GWN76xx Firmware Release Notes

- **Added L2TPv3 tunnel support.**

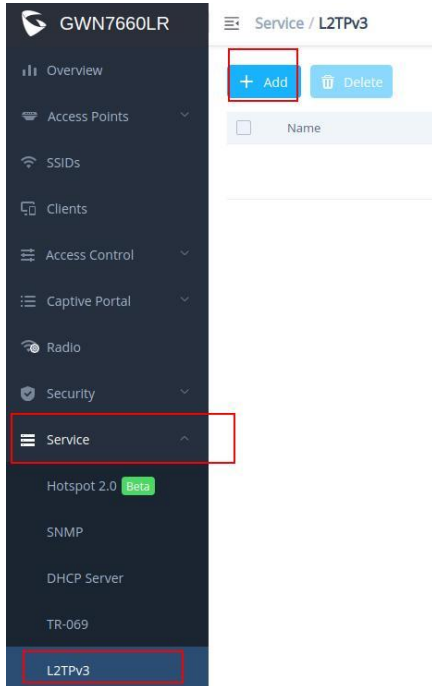
This feature will allow admins to enable and configure L2TPv3 on the device. Please refer to the screenshots and options below.

Note: It is best to set the MTU to match the server to avoid network connectivity issues.
